4. EXHIBITION CONSULTATION AND SUBMISSIONS

5. ASSESSMENT

5.3 Construction Traffic

Figure 9: Variation in average daily concrete truck movements – 'red' shows truck movement with concrete batching plant operation and 'blue' shows truck movements without concrete batching plant operational.

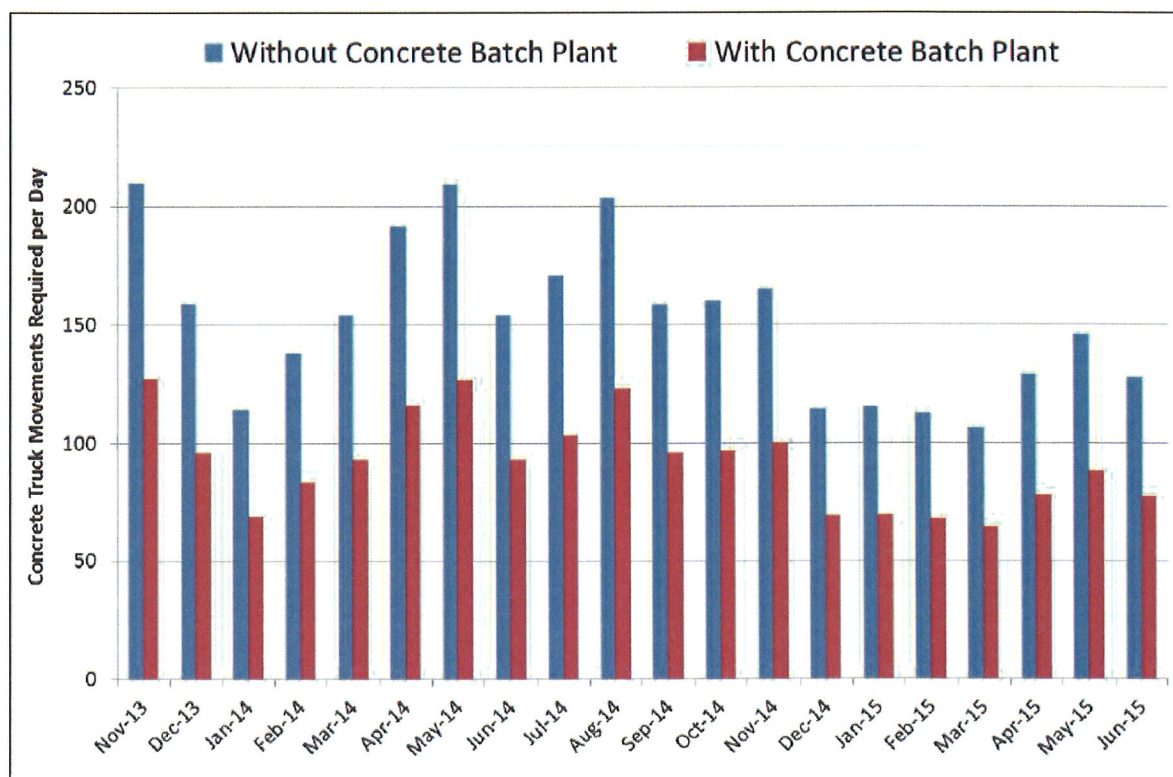
The forecasted truck movements to the site, for the known construction period to June 2015, with the batching plant operational are illustrated in red in **Figure 9** below. This represents a minor increase in the number of truck movements associated with the operation of the concrete batching plant. This is a result of the production capacity of the concrete batching plant increasing from 1,200m³ required for the construction of the basement car park (MP10_0023 MOD 4) to 1,600m³ required for development in the remainder of Barangaroo South on large pour-days. Based on Planning and Infrastructure's review of this data, the following can be concluded:

- The predicted truck movements will vary significantly depending on the construction schedule; and
- The ongoing operation of the concrete batching plant will continue to substantially reduce the average truck movements to the site as concrete will no longer need to be delivered to service the construction of other buildings on site. This is typically in the order of a 40% reduction when comparing the reduction in concrete related traffic deliveries from the use of the batching plant against the total number of concrete related heavy vehicle movements for all of Barangaroo South (for the duration of the plant only).

Figure 10: Batching Plant – west elevation

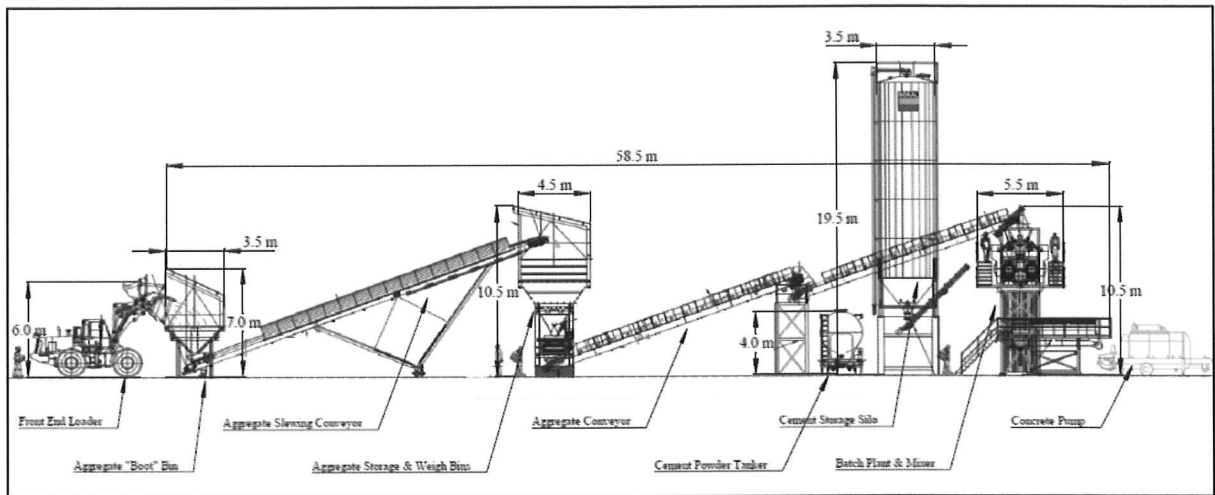
The concrete storage silos and associated components of the concrete batching plant are currently visible from the surrounding public domain and neighbouring premises which have views to and over the development site. The cement storage silos attain a maximum height of approximately 19.5m, as illustrated in the **Figure 10** below.

Planning and Infrastructure is satisfied that the visual impact of the proposal is acceptable due to its temporary nature and furthermore, having regard to other construction activities on the site. It is noted that there is no height limit applying to the land on which the concrete batching plant is sited and therefore, the proposal is not inconsistent with the provisions of the MD SEPP and the Concept Plan.
